SERVICE BULLETIN

Document ID:
SB275

Title:
**Updating Ranger RS Wiring for BLADE
Software 9.7.x**

Affected machinery: Ranger Lumber Retrieval System

Figure 3: Load Arm Board Cable Connector

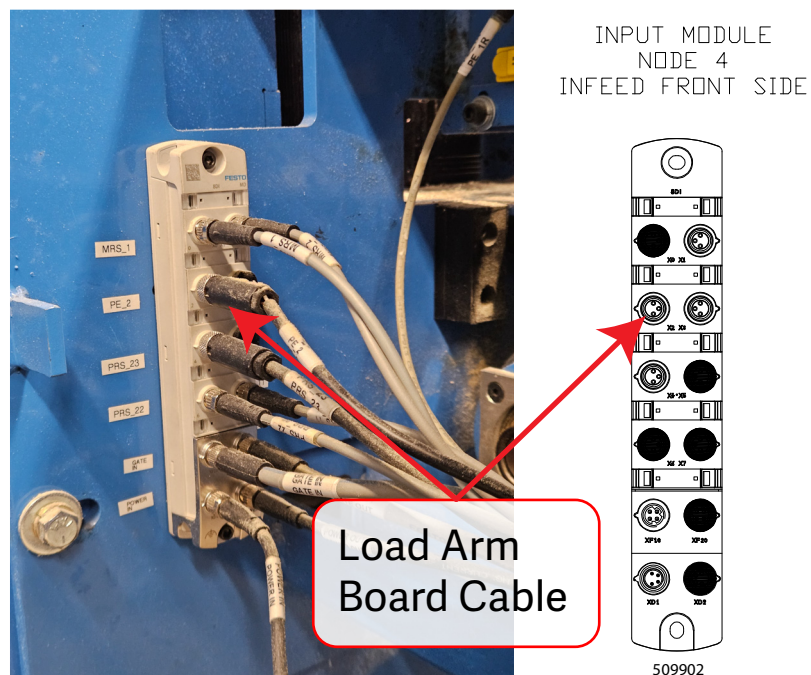
3. Disconnect the Load Arm Board Cable from the Festo I/O block's X2 connector. It is the first connector in the second row of the block. See [Figure 3](#).

Figure 4: Electrical Enclosure with Spliced Wires

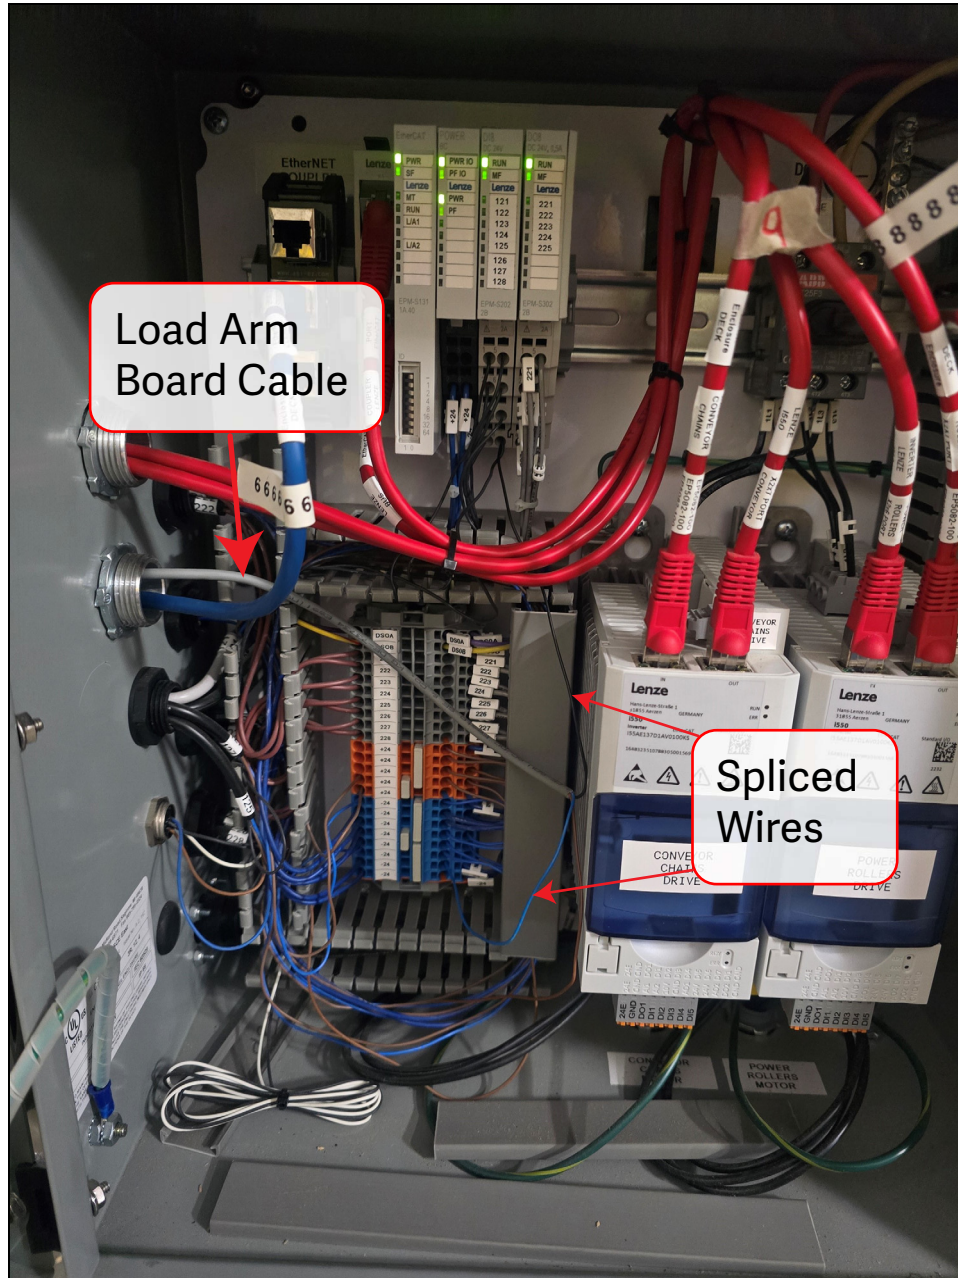
4. Follow the cable to the universal deck electrical enclosure and locate where the two wires (1 blue, one black) have been spliced into the box. See [Figure 4](#).

5. Using a screwdriver, remove both the blue and black wires from the terminal blocks they are connected to.
6. Remove lockout/tagout devices.
7. Update the BLADE Software to version 9.7.x.
 - Contact MiTek Automation Support for assistance.

8. After the BLADE Software has successfully been updated, test your machine to ensure all operations are performed as normal.
 - If there are any errors with the machine operation, the BLADE Software version must be rolled back and the wiring reattached.
 - If no errors occur, remove and discard the two wires from the enclosure.
